Re: Montgomery County
Intercounty Connector
Montgomery Auto Sales Park (8-06001 & 8-06002)

This office has reviewed the Site Plan (8-06001 and 8-06002) for the Montgomery Auto Sales Park dated June 2004. The 14.77 acres Montgomery Auto Sales Park Property is located south of Briggs Chaney Road and east of US 29. The Site Plan shows the proposed reconstruction of two existing buildings as well as changes to the existing parking lot.

SUBJECT: Preliminary Plan 120041060 and Site Plan Number 820060020,
Montgomery Auto Sales Park, Lot 11

SUBJECT: Preliminary Plan No. 1-04106/Site Plan No. 8-06002
Addition of ~~42,000~~ 42,189 square feet of commercial density on Lot 11 for a
maximum density of ~~160,233~~ 175,891 square feet
Montgomery Auto Sales Park Expansion (Herb Gordon Auto World – Mile One)
Automobile Boulevard
Fairland/White Oak Policy Area

CORRIDOR 1
 CHECK IMPACTS TO
 MONTGOMERY AUTO
 SALES PARK REDEVELOPMENT
 SCALE IN FEET
 0 25 50 100
 INTERCOUNTY
 CONNECTOR
ICC
 November 14, 2005 Study

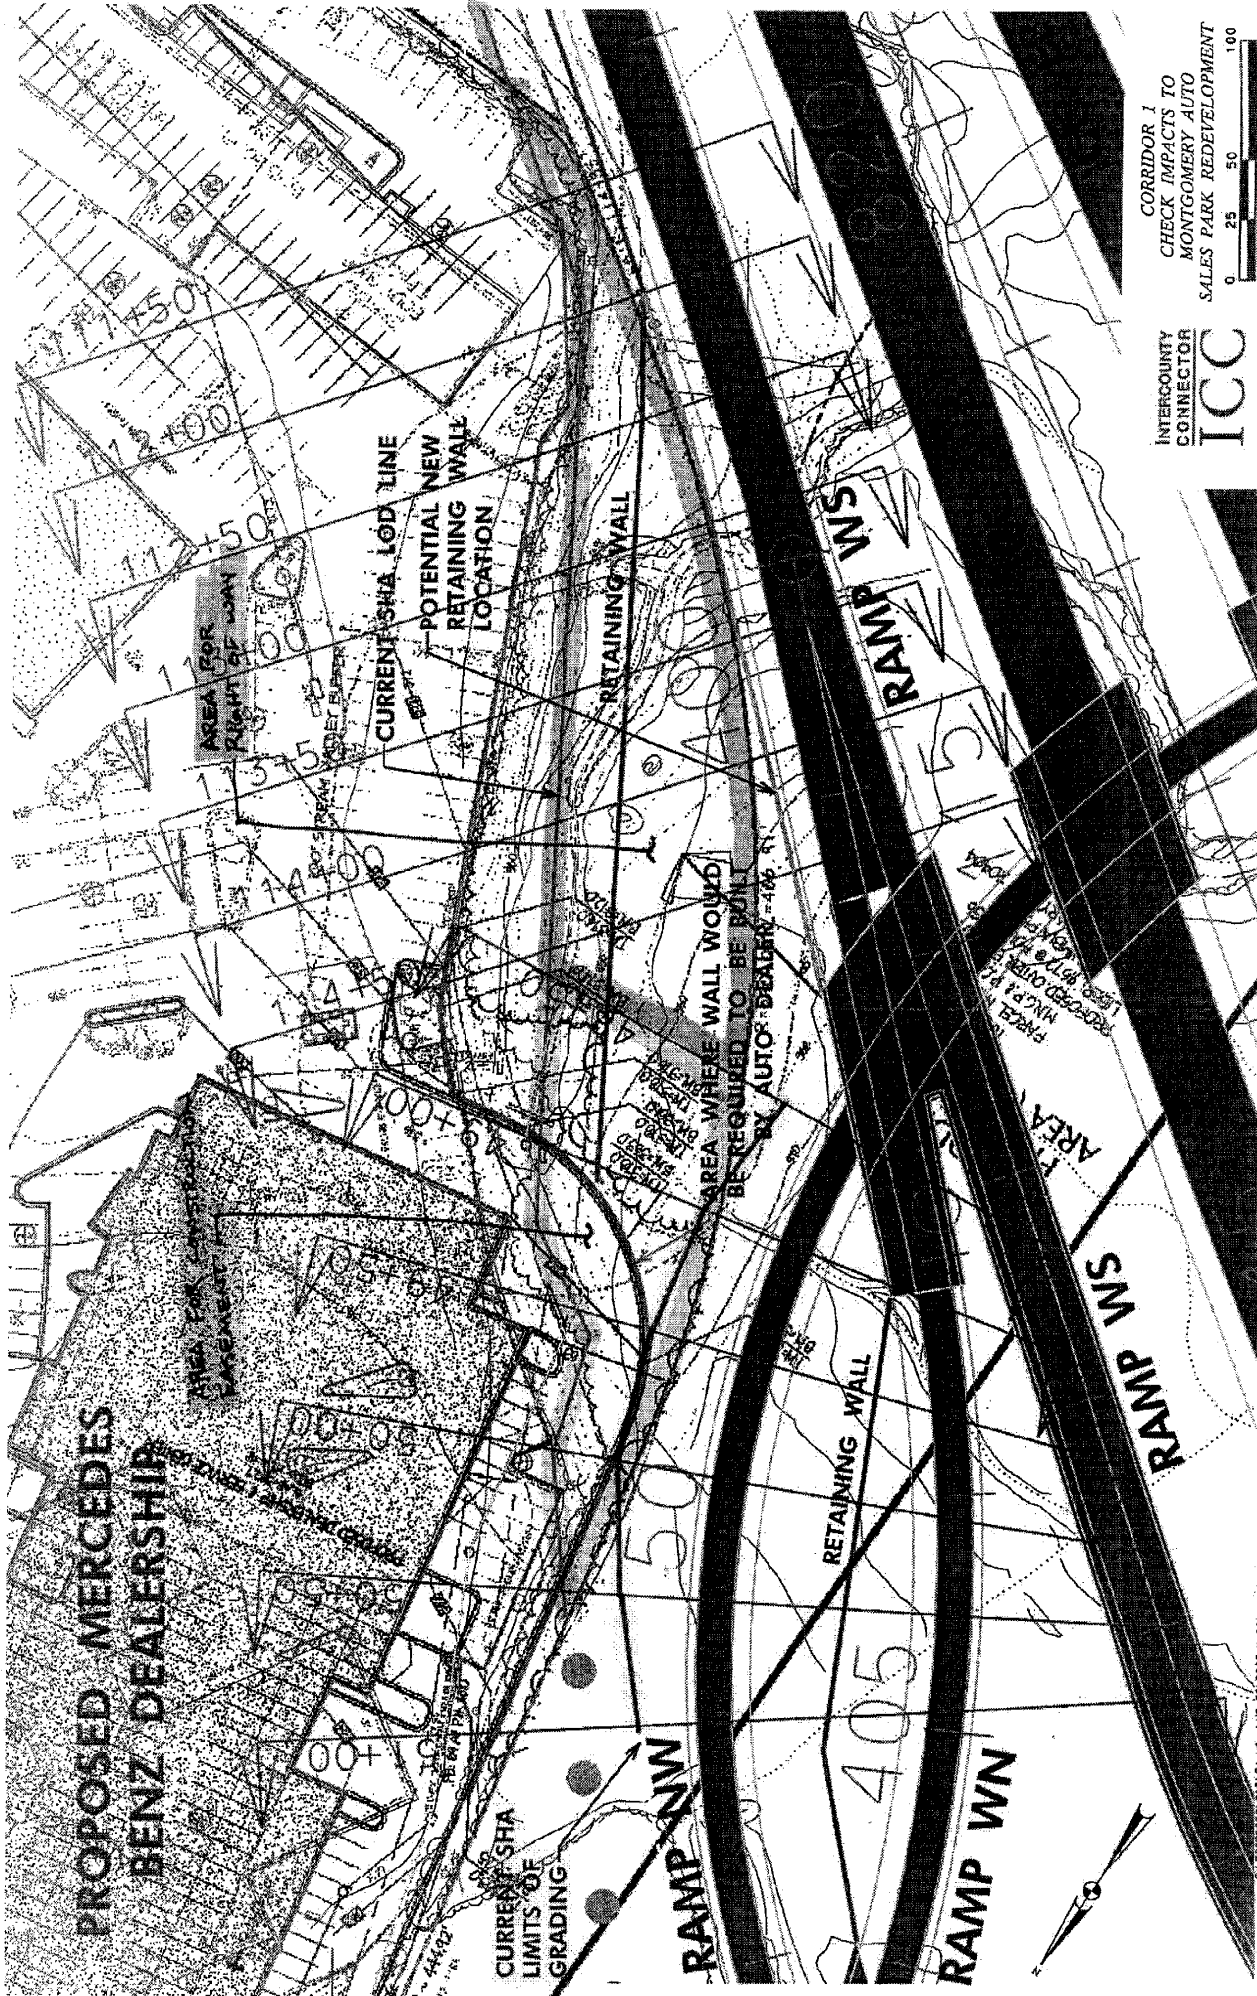
The Intercounty Connector (ICC) Corridor One, as shown to date, impacts about 0.80 acres of the property, as shown on the attached map. About 0.29 acres of this impact (highlighted in purple on the attached map), located right station 48+50 to right station 50+55 along ramp "NW", is due only to grading for supporting slopes, and could be handled as an easement. The remaining 0.51 acres of impact (highlighted in orange on the attached map) contains a potential retaining wall, and needs to be acquired as right-of-way.

To protect property that will support the State Highway Administration/Maryland Transportation Authority (SHA/MdTA) locally preferred alternative, Corridor One, which is being studied as part of the current National Environmental Policy Act process for the project, we request that your agency require reservation of this property through the project's Record of Decision scheduled for release on April 1, 2006. In addition, we request that the Site Plan approval be made contingent upon the owner continuing to work with the SHA regarding grading and drainage to make certain that neither the owner's or SHA's interests are precluded by the other.
